EL PASO COUNTY DEVIATION REQUEST AND DECISION FORM

PCD File No. SF2514

Project Name	Monument Ridge East Filing No. 1
Schedule No.(s)	7102200006, 7102200008, 7102200010, 7102200013, 7102201001, 7102201014
Applicant	Monument Ridge East, LLC (Donald Cannella, Manager)
Engineer	PRC Engineering (Raymond E. Perez, P.E. #37173)
Deviation Requested	ECM Section 3.2.6 – Transfer of Drainage Basin Flows (Existing Basin MM to Future Basin C1F / EDB Pond 3)

D4
sheet number

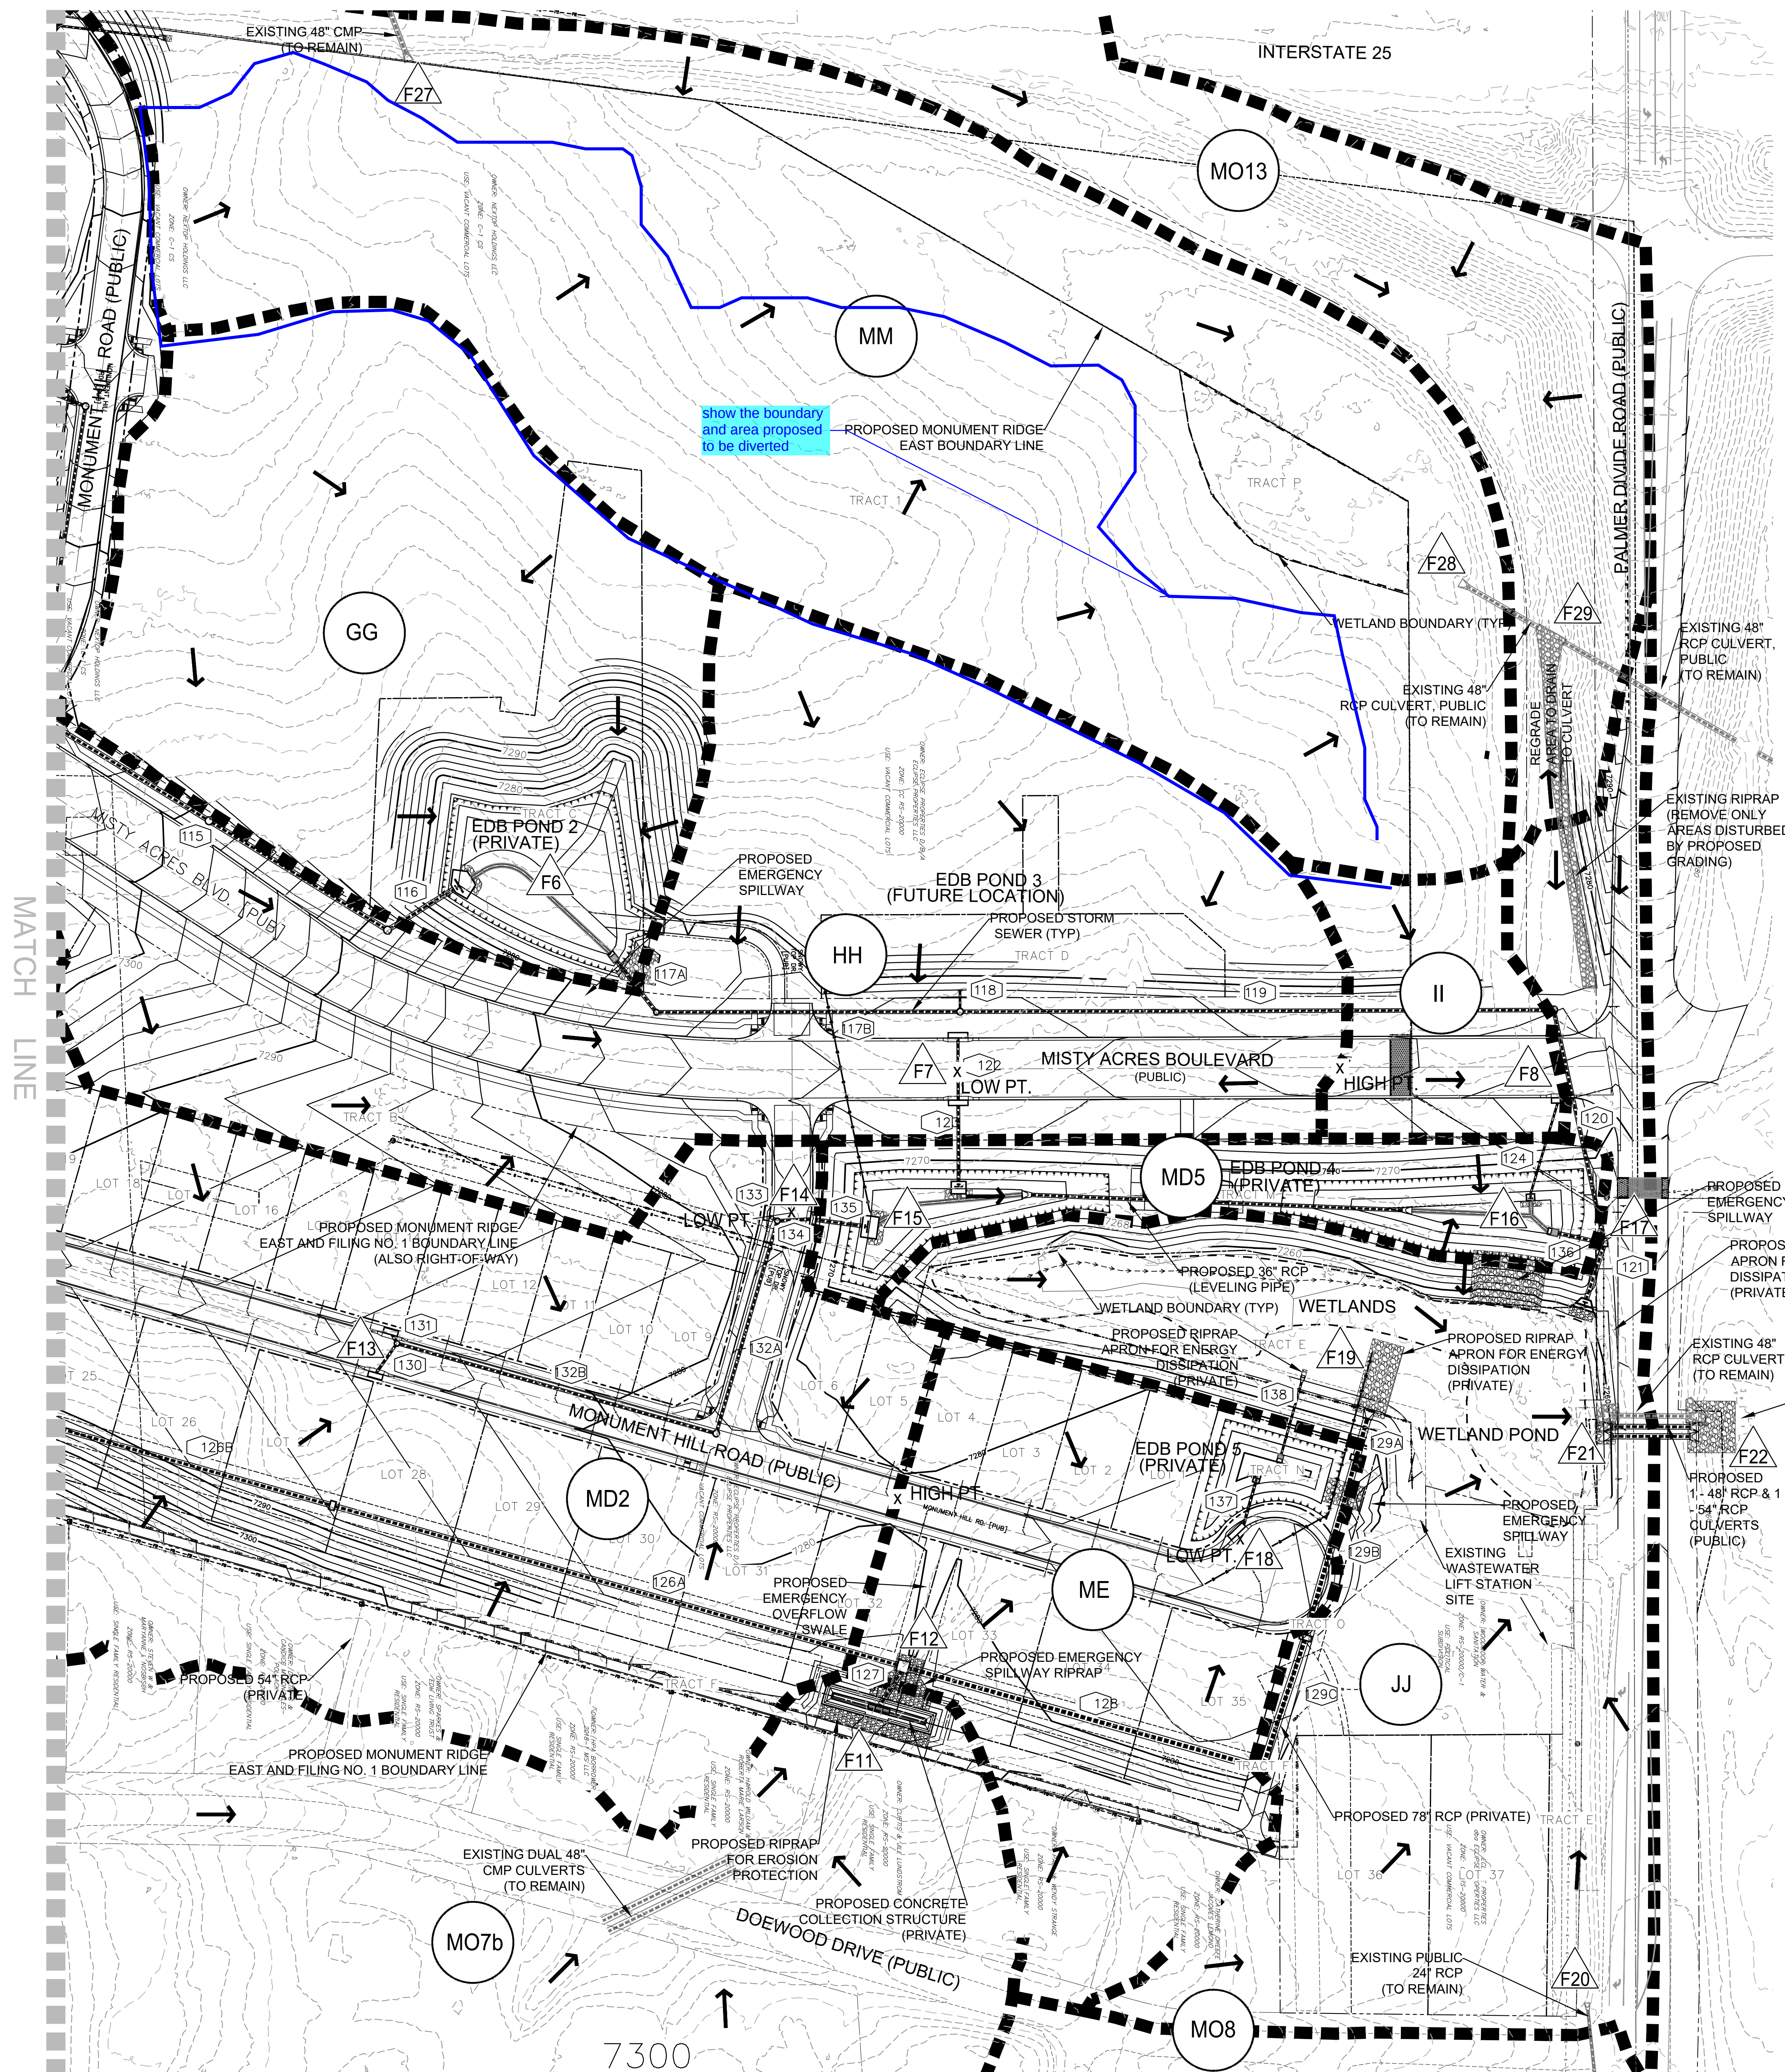
Provide offsite easement drafts for review

Include MHFD sheets and peak flow routing summary with the deviation request showing allowable peak flows and combined peak flows at the storm drain system outfall (interim and final conditions)

Drainage Outfall Exhibit

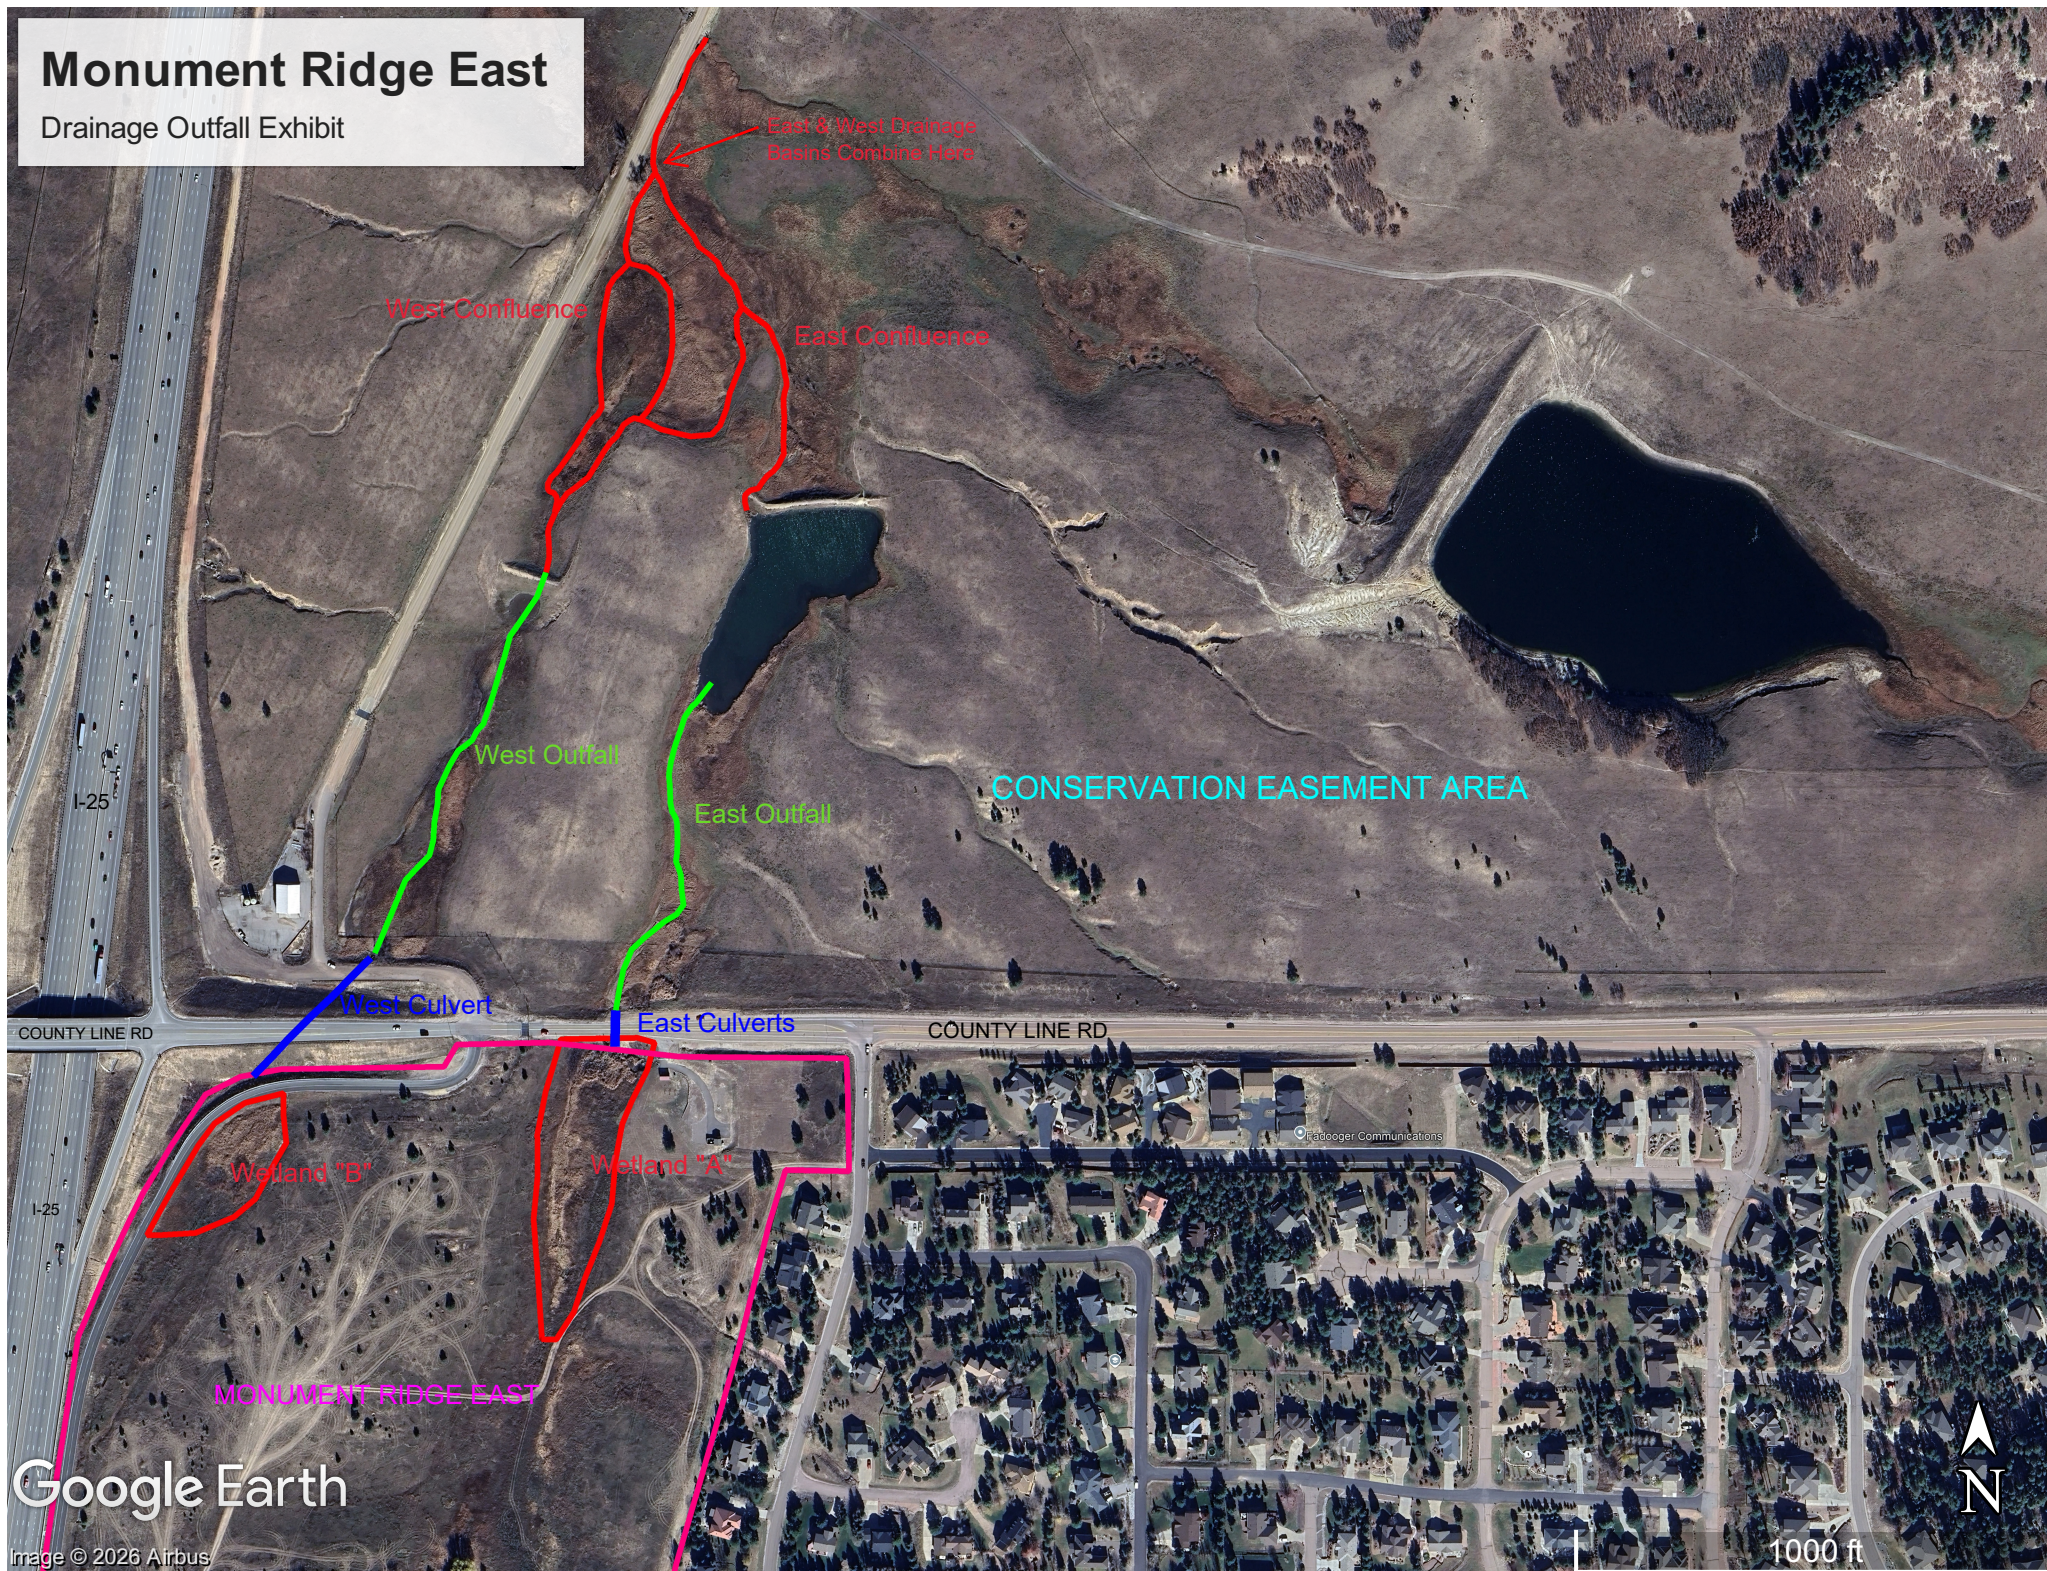
Address the downstream receiving channel

Provide complete analysis, including runoff volumes, durations, flow regime, shear stress and velocity calculations, and any necessary downstream improvements to the historic confluence
